**Preliminary Alternative Technical Concepts (ATC) Submittal**  
**BEL-70-9.35 Interchange Improvement**  
**Design-Build**  
**Belmont County, Ohio**  
**PID 120547**

## Contents

BEL-70-7.61

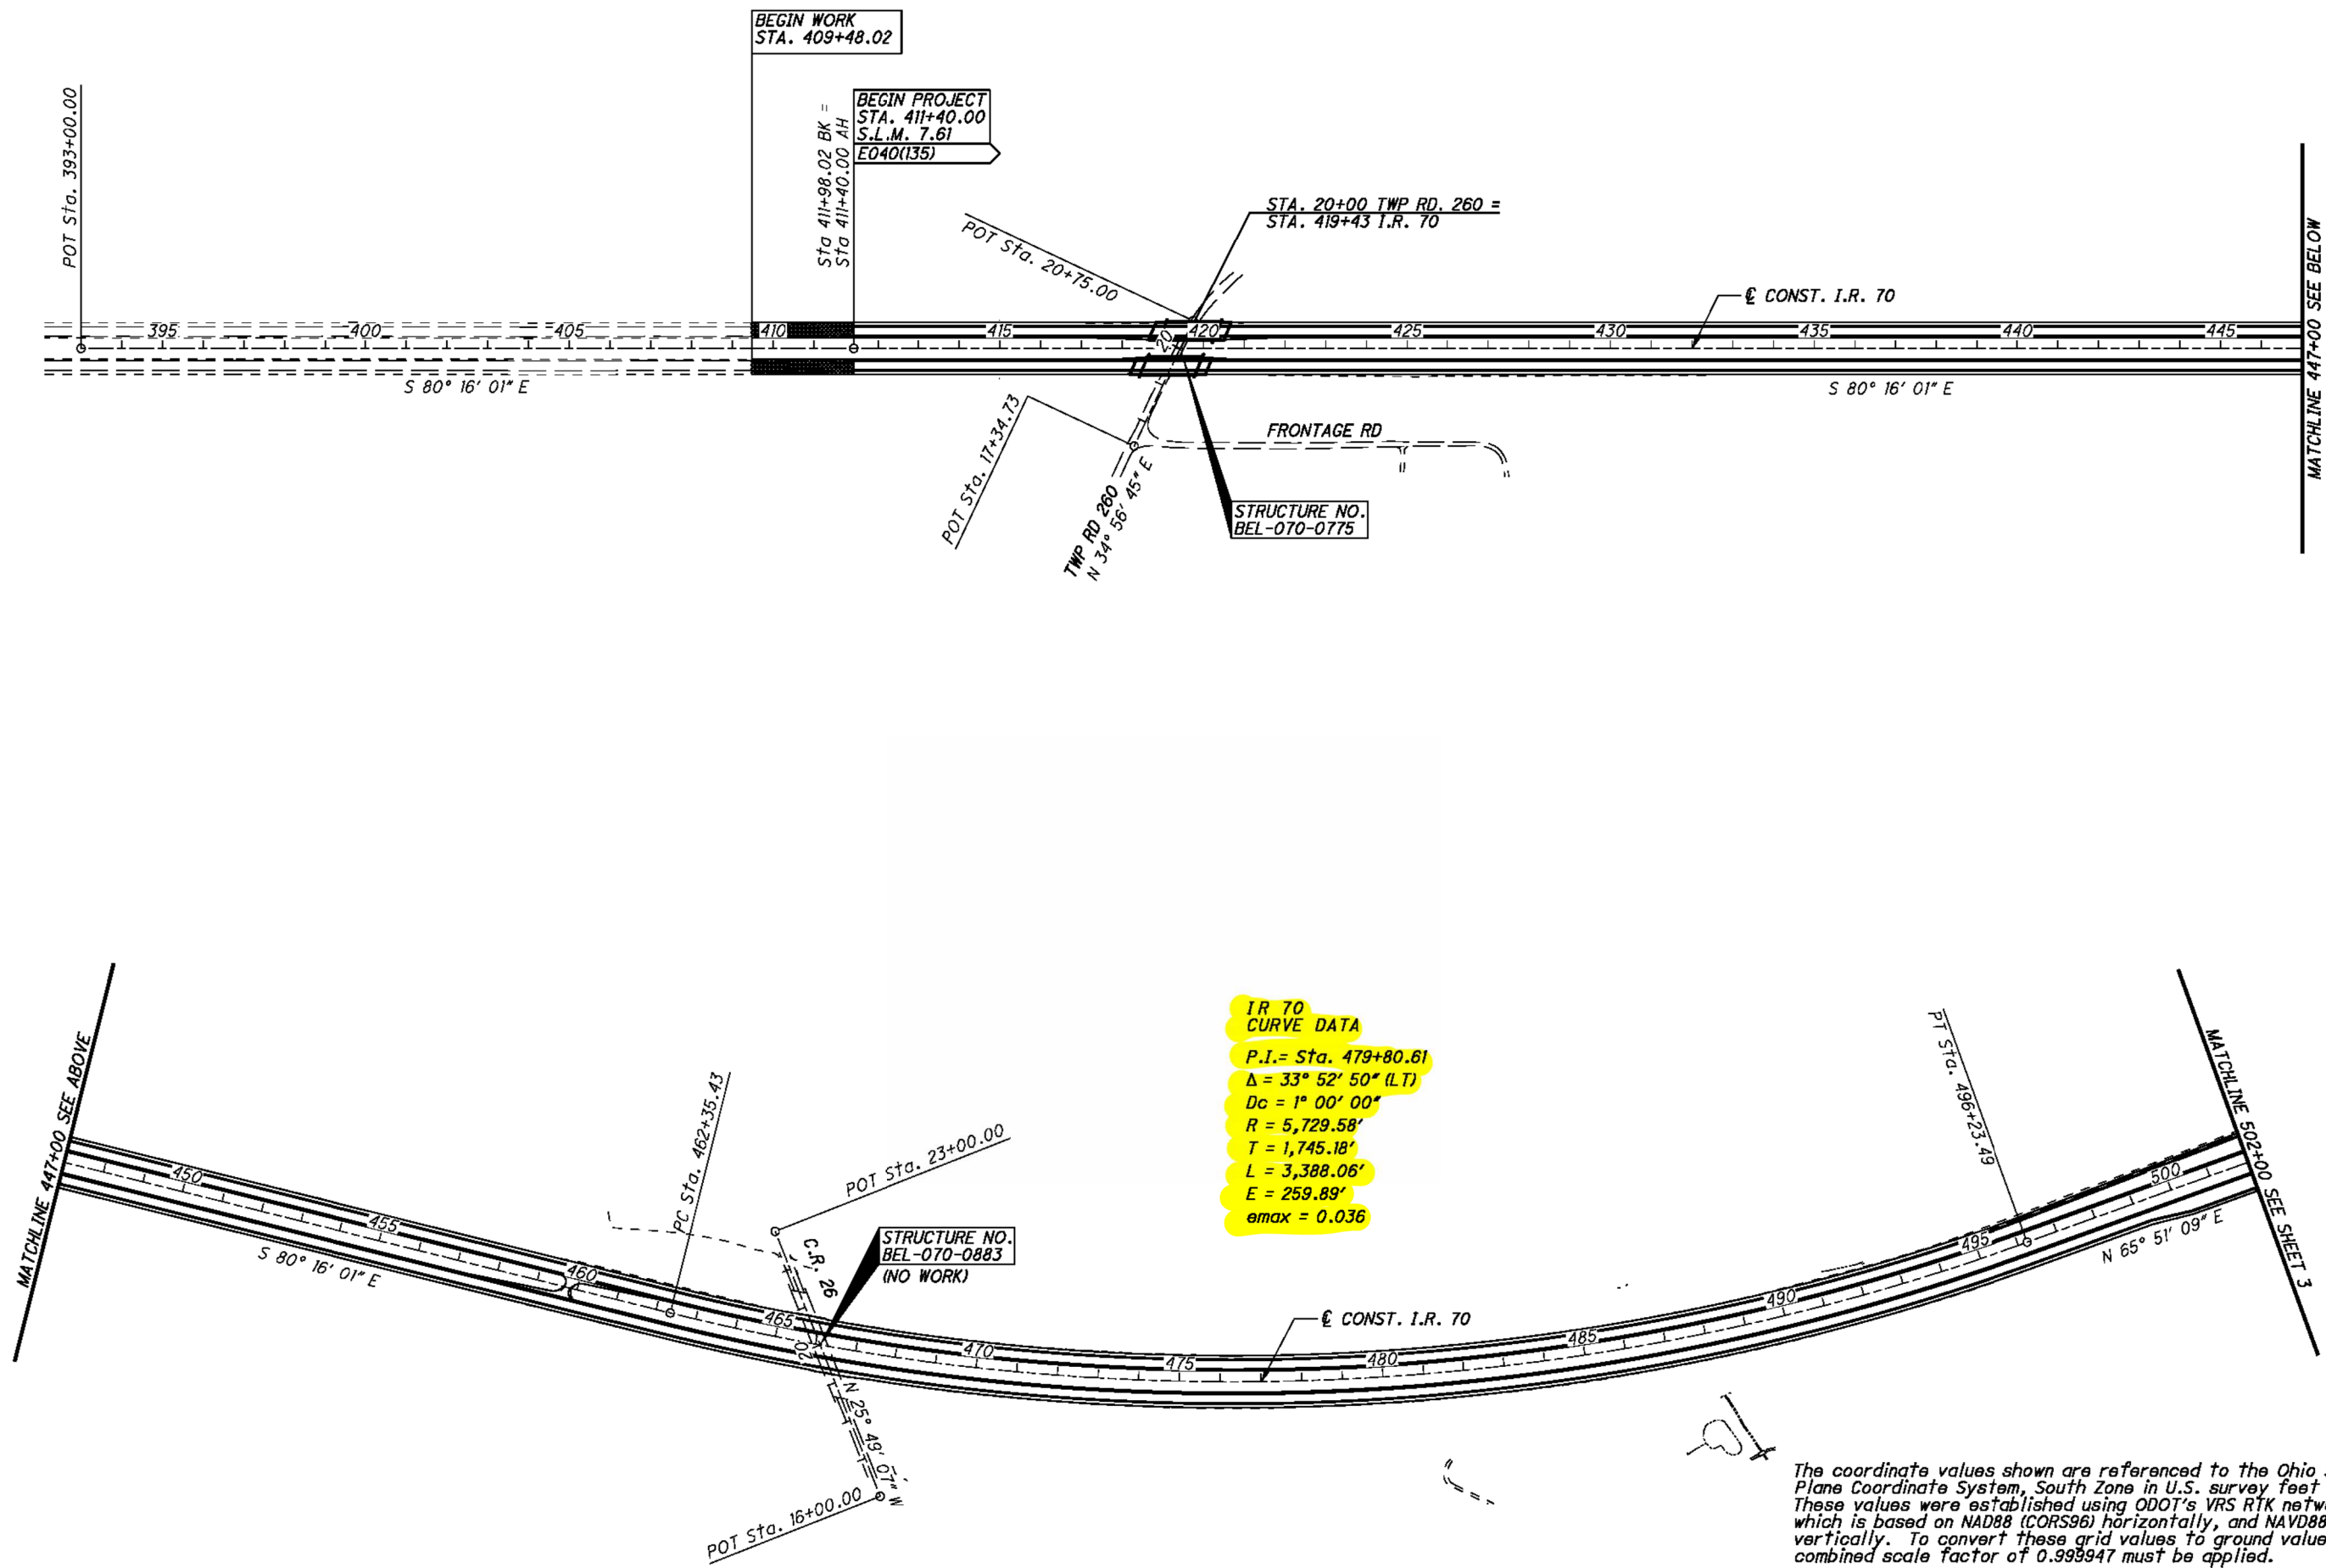
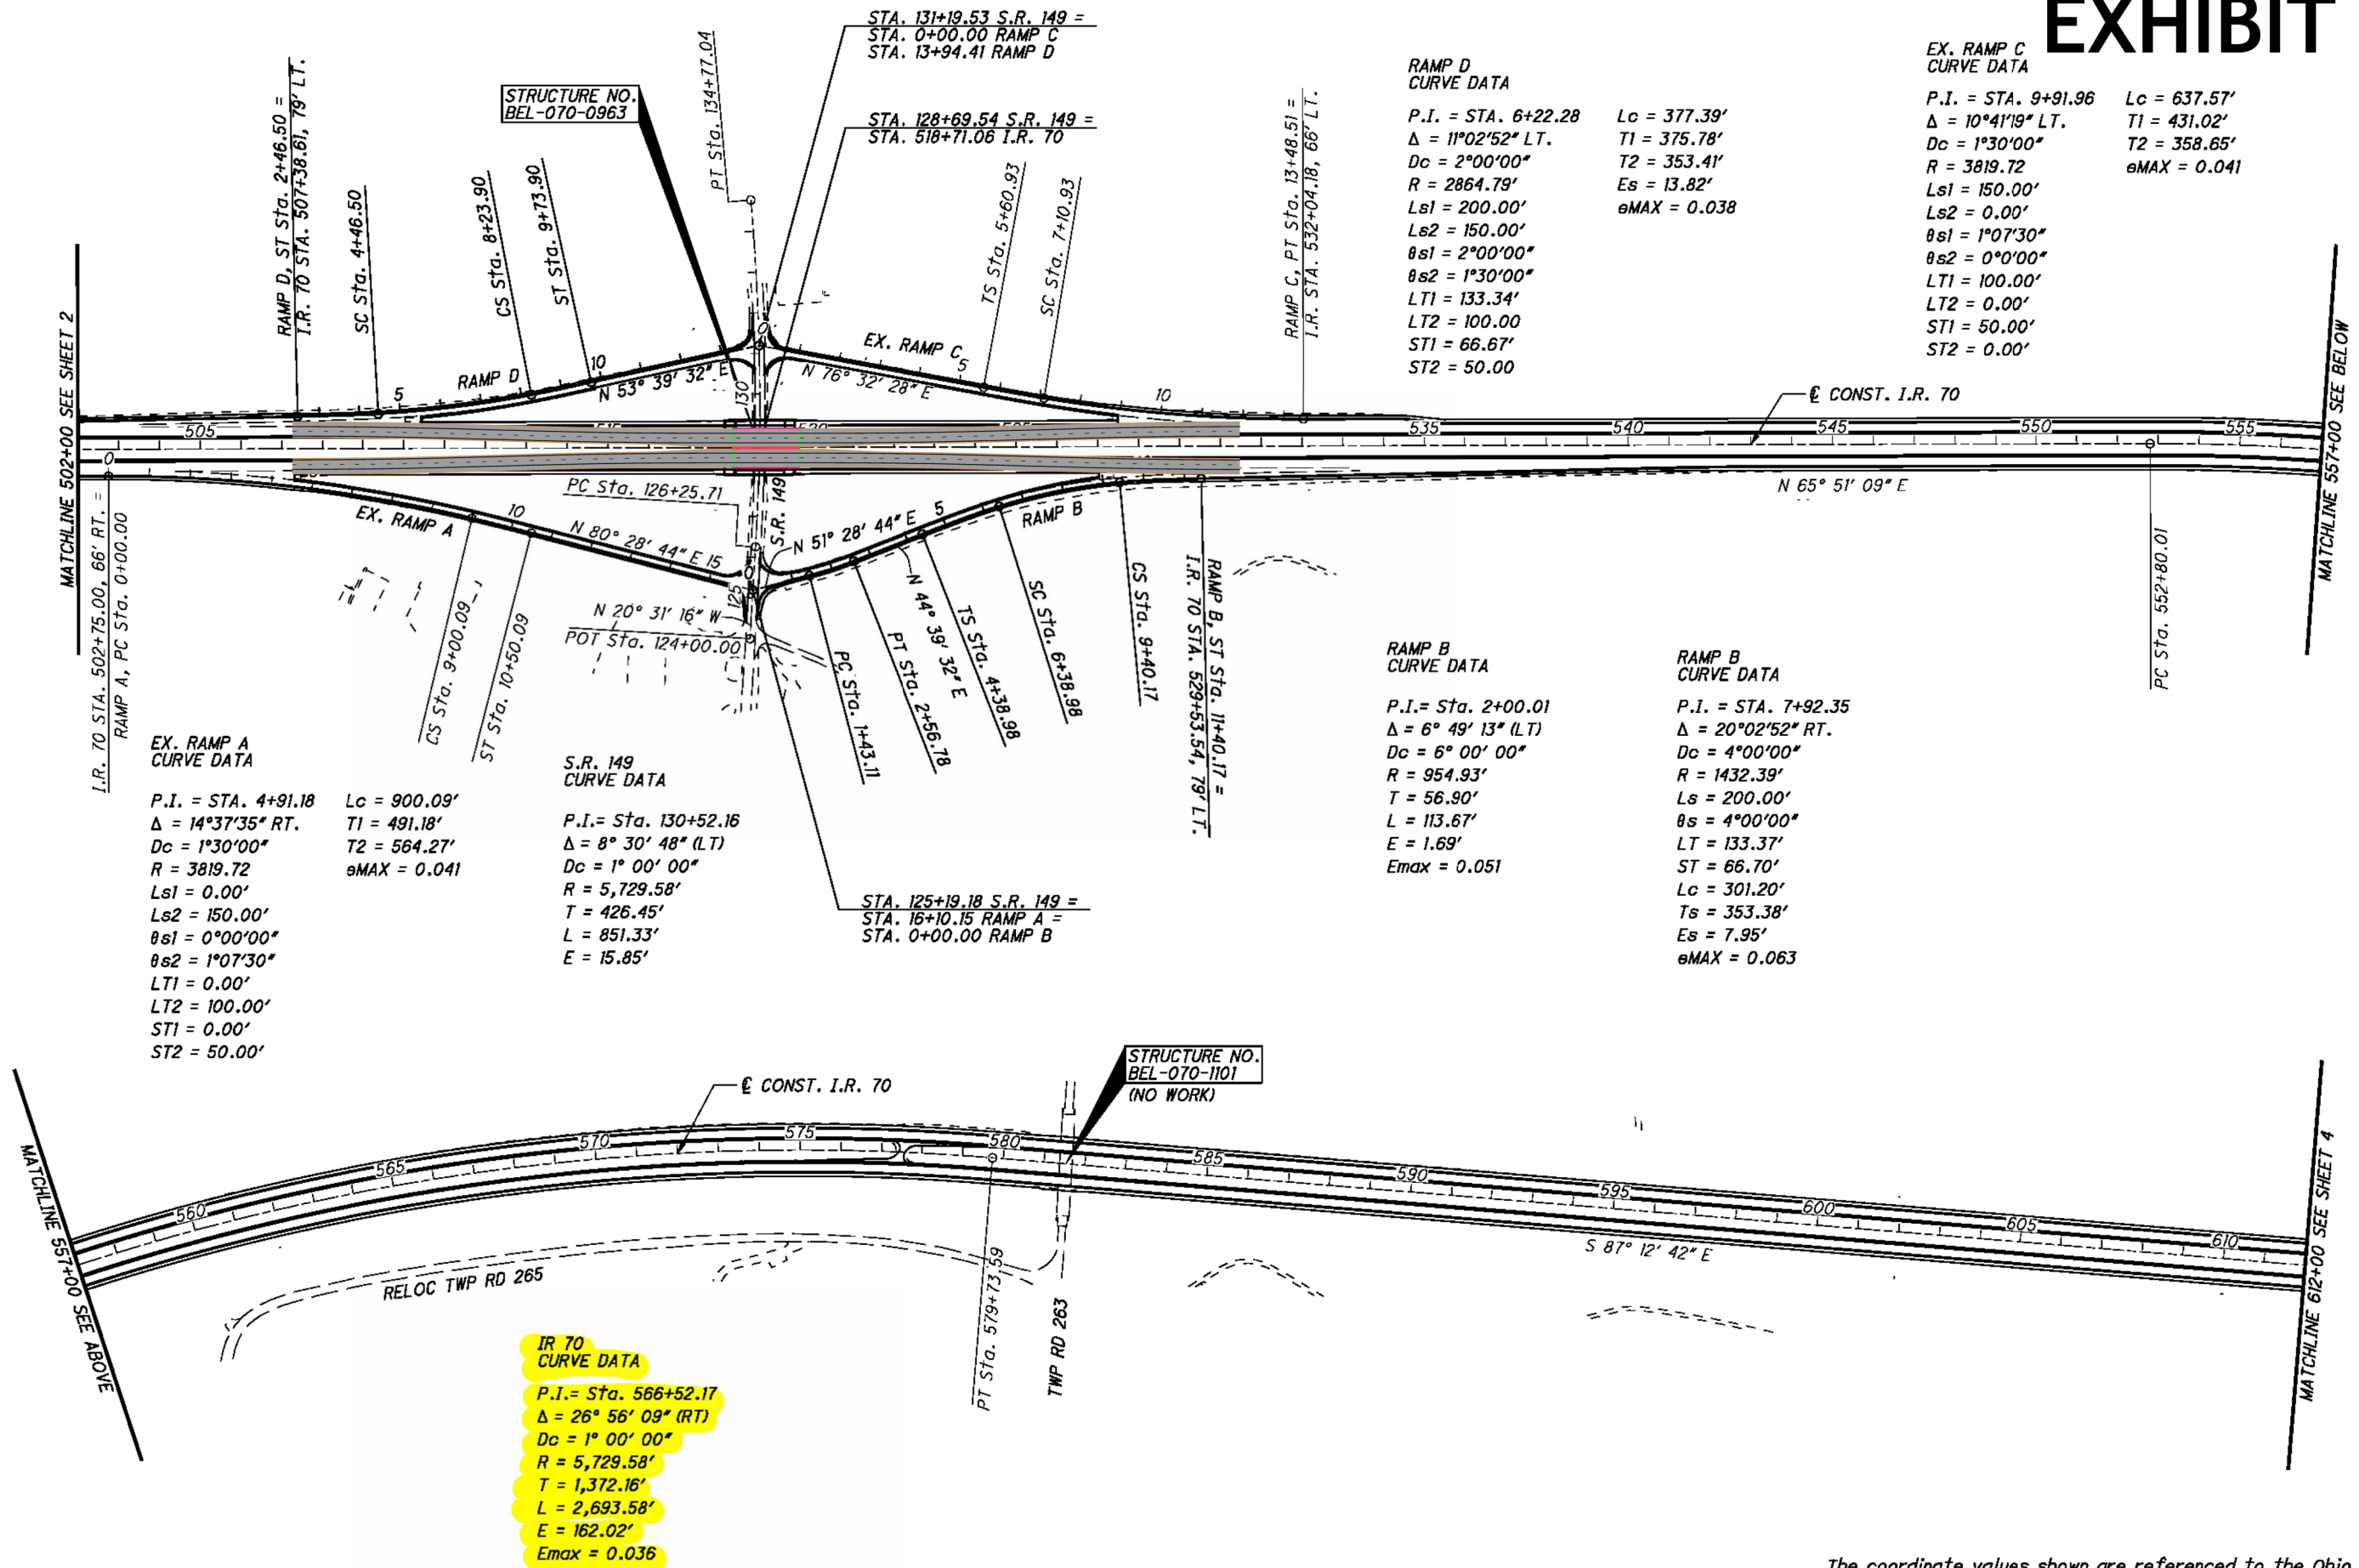
1. **Description:** This ATC proposes a modification to the dimensional requirements outlined on Page 38 of 63 of the BEL-70-9.35, PID 120547 SCOPE OF SERVICES (Addendum 1). The original specification mandates that the 42' dimension between the Centerline Survey IR-70 and the Centerline of WB and EB IR-70 lanes shall be held and not deviated from.

The DBT proposes modifying this requirement to align with the Location and Design Manual. This change enhances design flexibility, ensuring roadway alignment and geometry adhere to established standards while promoting safer traffic flow by eliminating contraflow and reducing phasing of the project construction.

This includes curves that are similar to curves for both the upstation and downstation of the project. DBT proposes to use 75mph design horizontal curves meeting L&D Vol 1, Fig 202-3 separated by tangents set to a minimum distance of 3x design speed. Record plans show 5729.58-ft radius Hz curves east and west of our project limits. The proposed permanent shift includes 15,000.00-ft radius curves separated by tangents set to a length of at least 3x design speed. See Exhibit A for additional details.

2. **Deviation:** Page 38 of 63 of the BEL-70-9.35, PID 120547 SCOPE OF SERVICES (Addendum 1) states: *"The 42' dimension between Centerline Survey IR-70 and the Centerline WB and EB IR-70 lanes shall be held and not deviated from."*

The DBT proposes to modify the above language to state: *"The dimension between Centerline Survey IR-70 and the Centerline WB and EB IR-70 lanes shall be designed per the ODOT Location and Design Manual and ODOT Bridge Design Manual."*
